Re: **REQUESTED**
Changes to CMI Work Plan
Former Ciba-Geigy Facility
Lot 1102, 180 Mill Street
Cranston, Rhode Island

Requested Change No. 1: Alter clean soil cover contouring and vegetation plan

Requested Change No. 2: Modify clean soil cover design to support stormwater retention areas

C-7

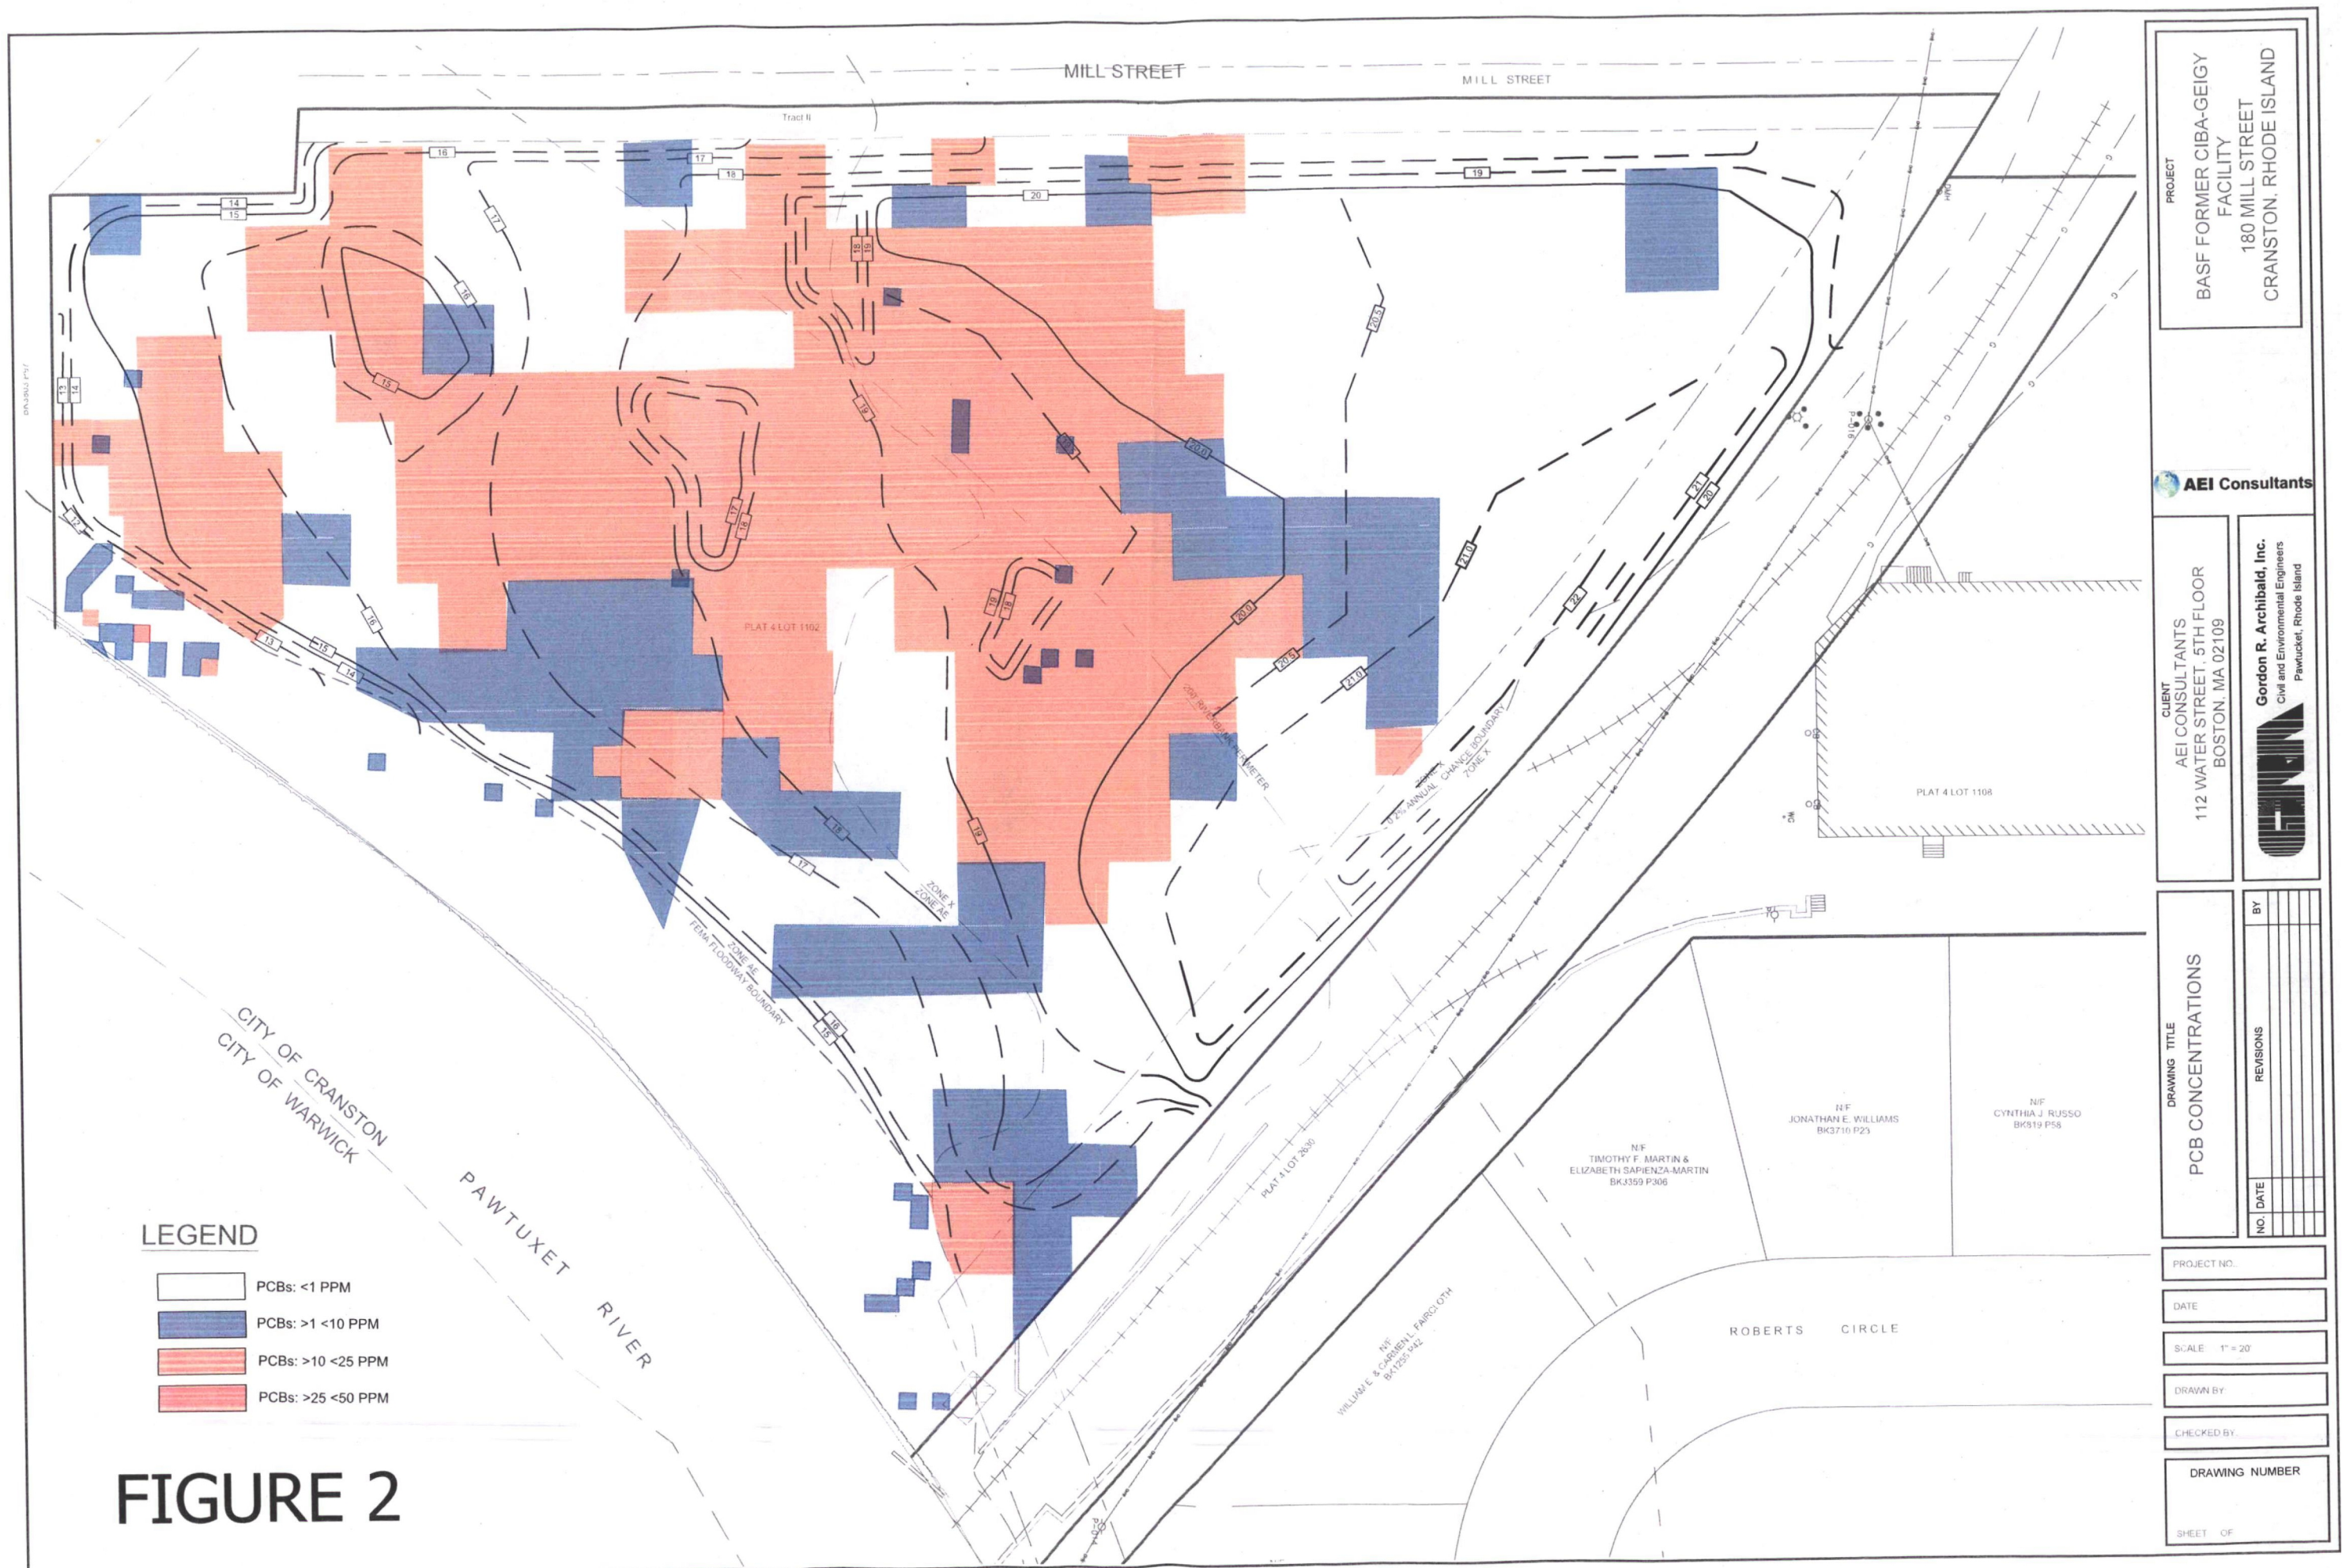
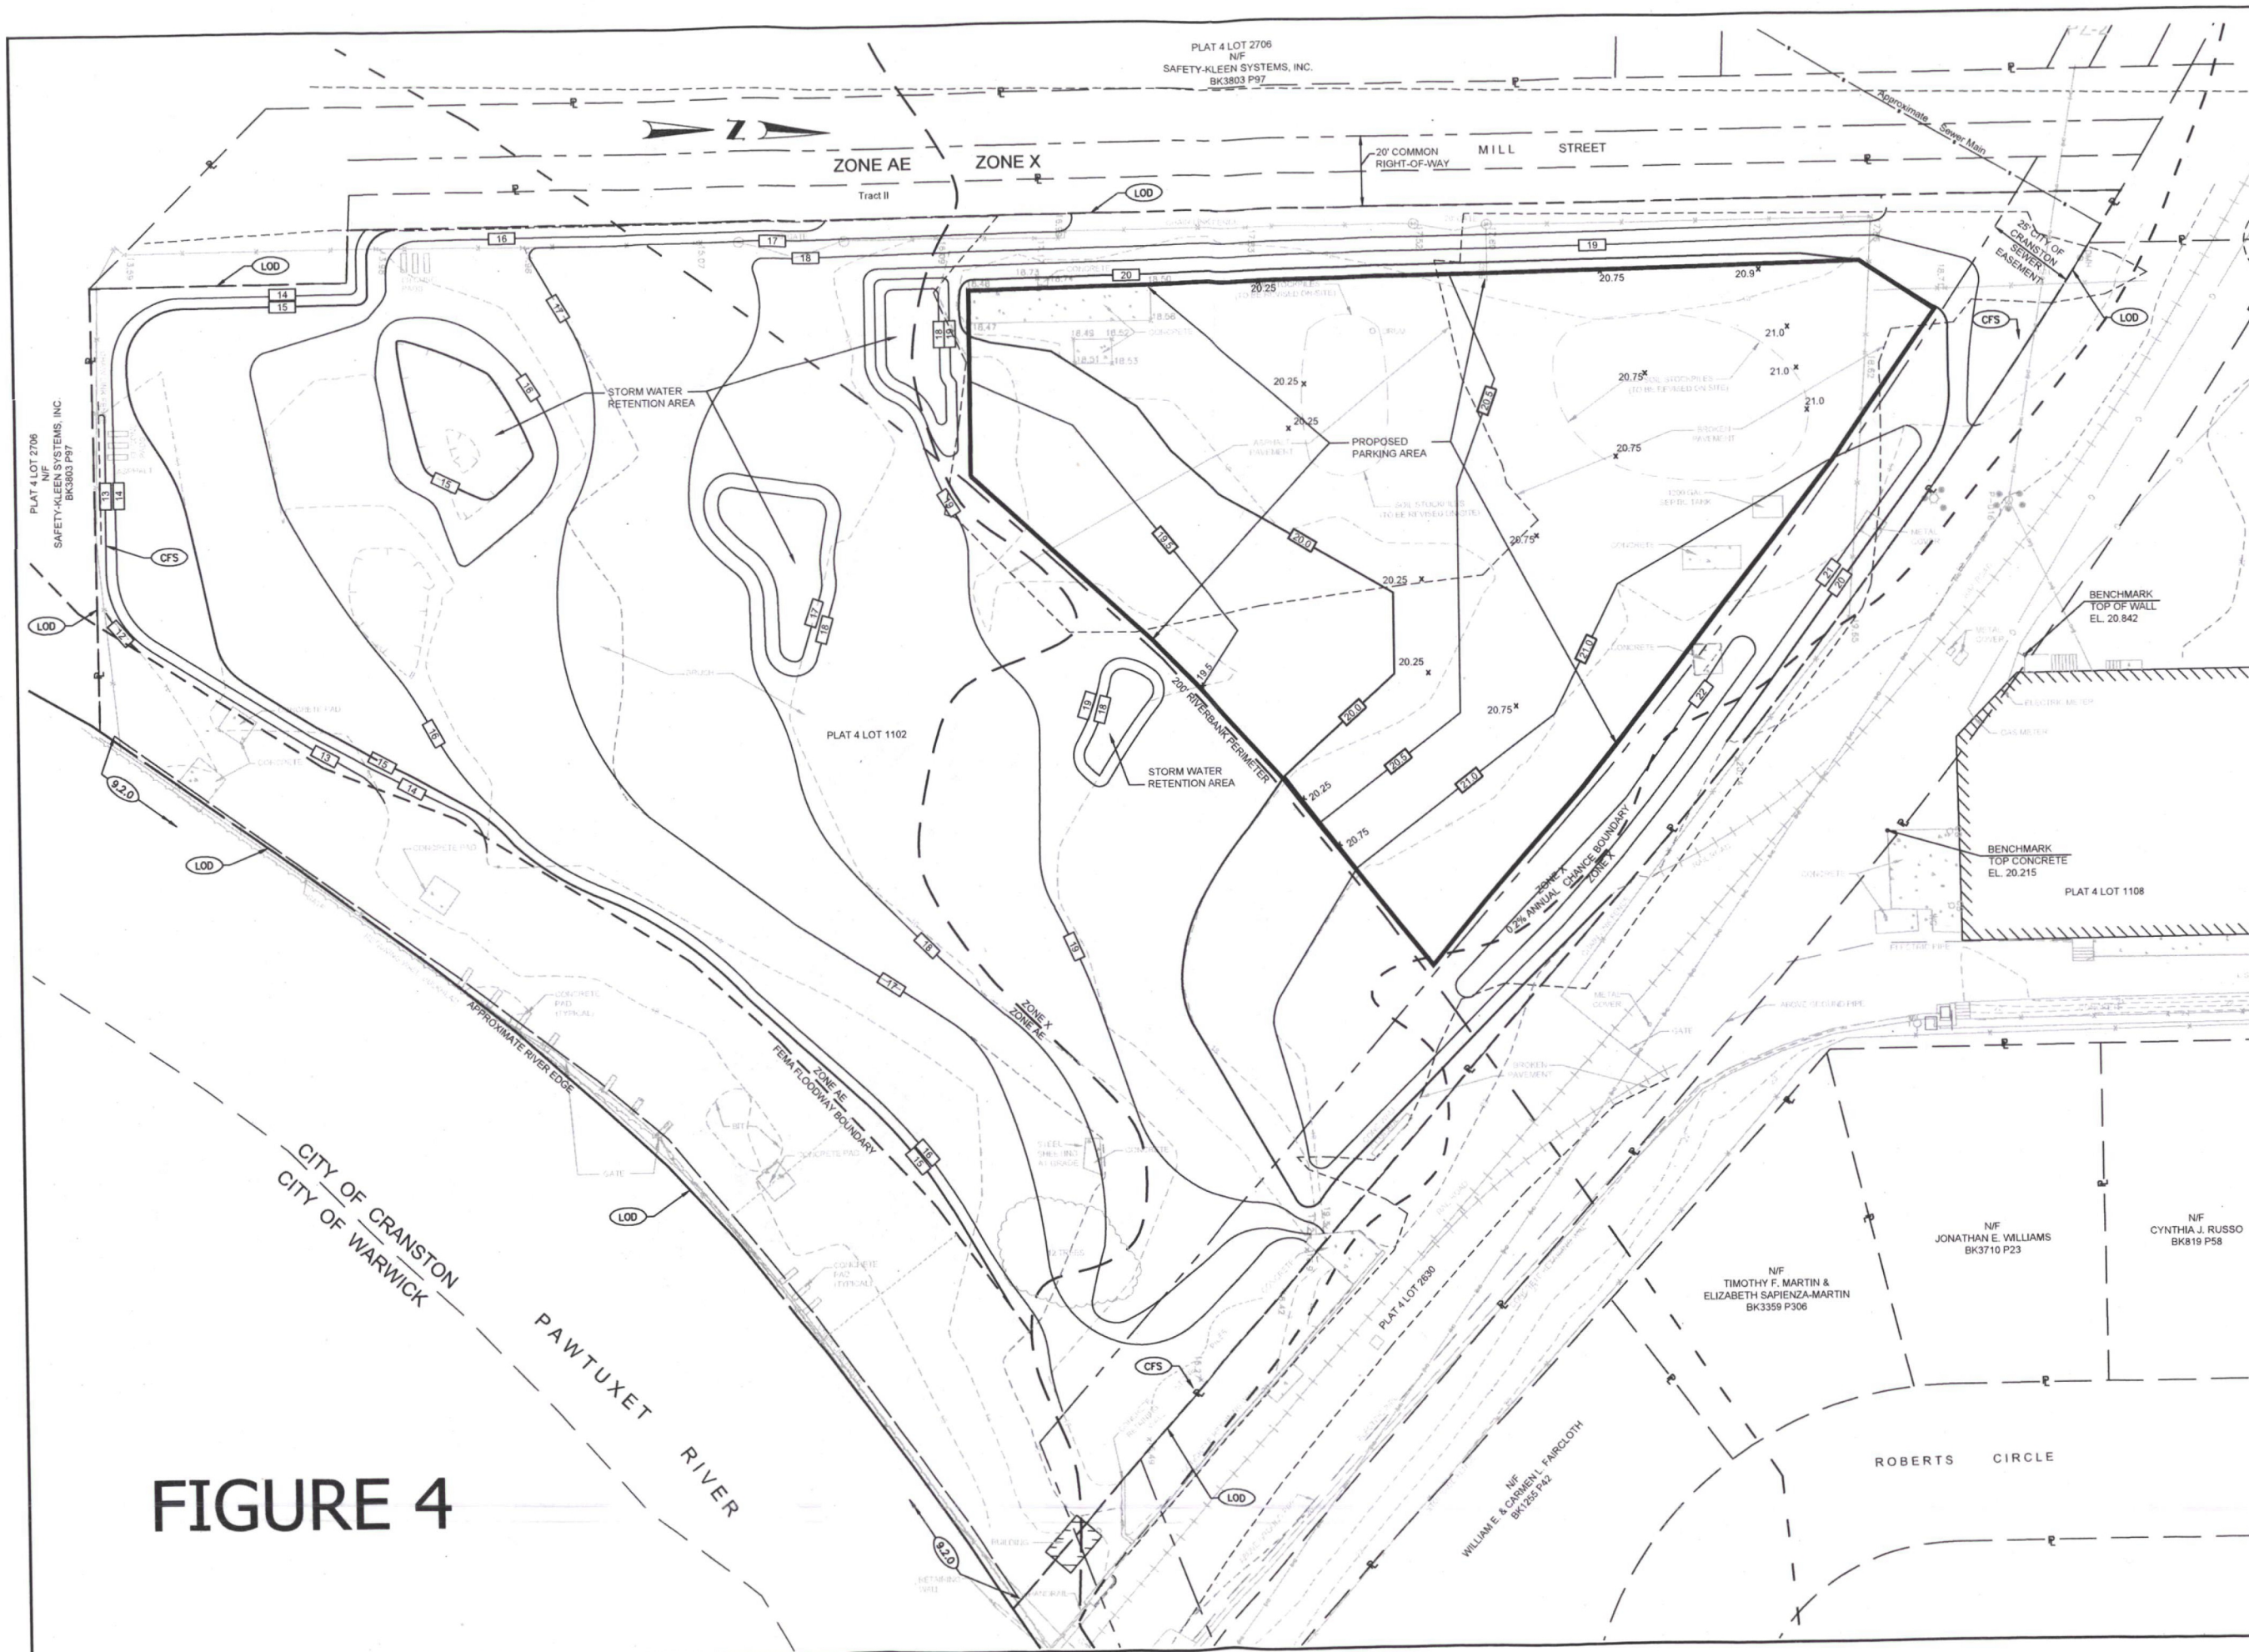
- **Vegetation:** The area beyond the 200' river setback will be maintained as an open field and planted with a wildflower mix, instead of the originally conceived upland habitat vegetation.
- **Contouring:** The area beyond the 200' setback will have a uniform grade, and the following alterations are proposed to accommodate surface water runoff control requirements associated with this design and potential parking area re-design (see drawing RC-7).
 - Stormwater retention basins have been moved to the periphery of the new open field.
